CRMC DECISION WORKSHEET

The Dunes Club

**STATE OF RHODE ISLAND
COASTAL RESOURCES MANAGEMENT COUNCIL
ENGINEERING REVIEW**

Plans Reviewed: “The Dunes Club Seawall Protection, Narragansett, Rhode Island...” Sheets 1-6, Dated August 2025, Pare Corporation, stamped by Todd Turcotte, P.E. and “The Dunes Club...Temporary Access Plan...,” sheet 1 of 1, dated 3/19/2025, by Race Coastal Engineering.

Figure 1: Shoreline Erosion Map

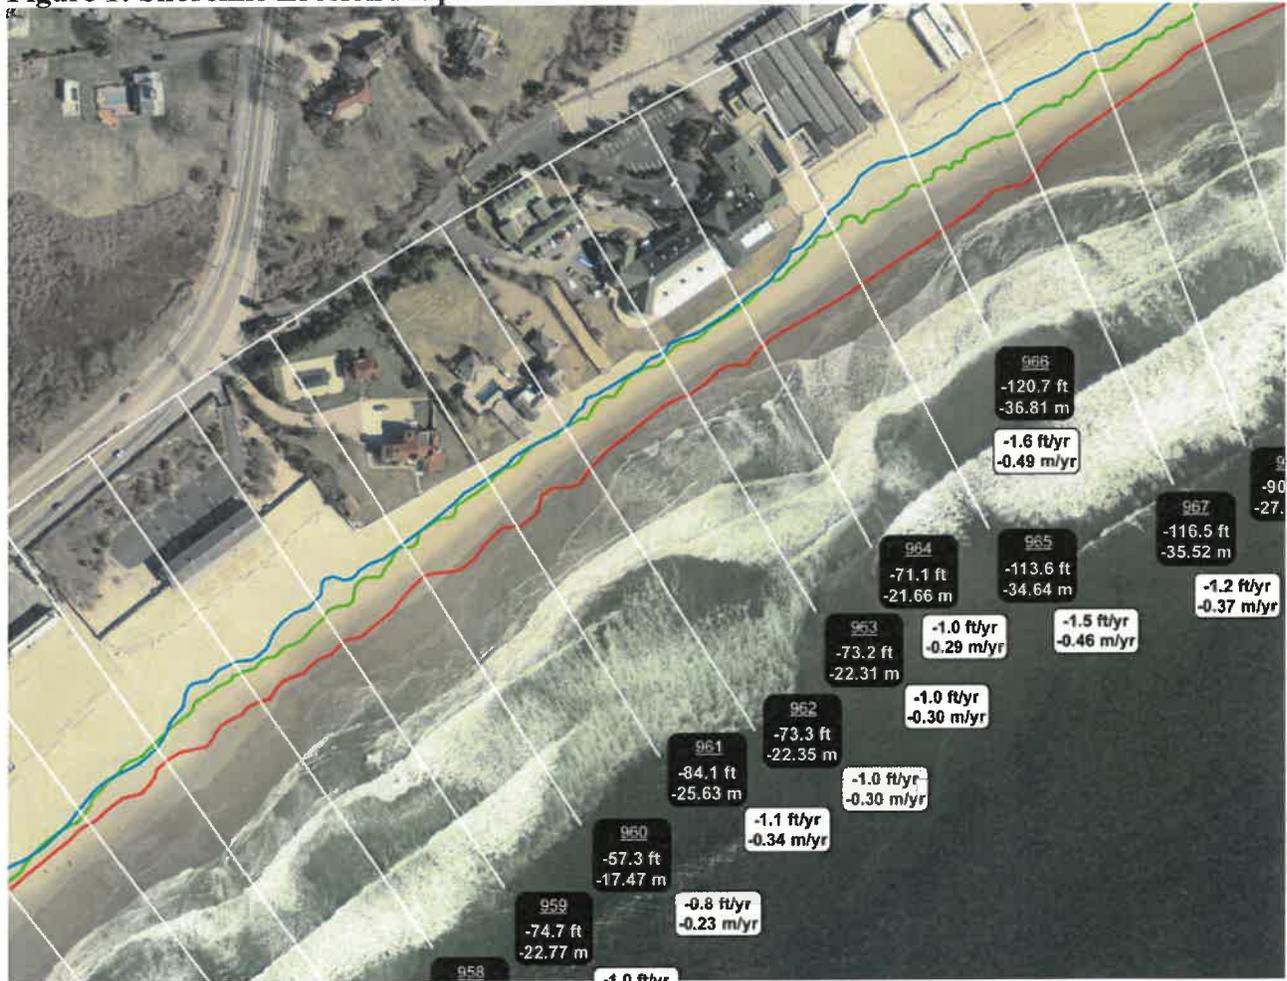
The project as now proposed is to stabilize the existing vertical seawall in the event of erosion which could cause undermining of the existing footing and structural failure of the wall. Erosion has been documented through erosion rate studies as a severe problem at this location (reference CRMC predicted erosion rate maps (see attached, Figure 1)), as well as staff observations. The new driven sheetpile will prevent soil loss underneath the existing footing and the tierods will provide further resistance from failure. It is staff engineer’s opinion that the project will help support the structure from potential failure.

Of particular concern is the existing level of lateral public access along the shoreline between Narrow river inlet/outlet and Narragansett beach throughout the year. As noted, this stretch of shoreline is heavily used throughout the year by the public. Episodically, erosion takes place in front of the existing wall exposing the footings and the tide reaches the face of the wall, making lateral access very difficult or impossible to maneuver. This design to stop scouring involves the installation of new sheetpile that extends to a depth beyond the predicted scour of 3’ to 3’-5” will most likely exacerbate erosion seaward of the wall. The resulting erosion will further reduce public access along the shore over time. Please note, the scour protection wall will be installed one foot seaward of the existing footing and staff has requested the designer Todd Turcotte, P.E. (email 10/22/2025 and 10/31/2025) to justify not cutting back the footing such as is proposed for Barry’s application (CRMC 2025-01-058). The designer has stated that the footing size cannot be reduced because of the dimensions of the existing wall, the anticipated scour and that reducing the footing would jeopardize its structural stability (Reference letter dated November 18, 2025). *“The structural integrity of the concrete wall is dependent on that footing toe of the retaining wall. If we remove that the structural integrity of the entire wall will be in jeopardy and with the limited depth of the toe protection for the wall, there is not enough area to design an alternative repair. As you pointed out it is well documented that the footing is frequently exposed and in jeopardy of being further undermined, but to date it has been stable because the soil under the footing has not been compromised. Changing the design of the existing footing is not prudent or recommended, as this wall is different than the Barry wall.”*
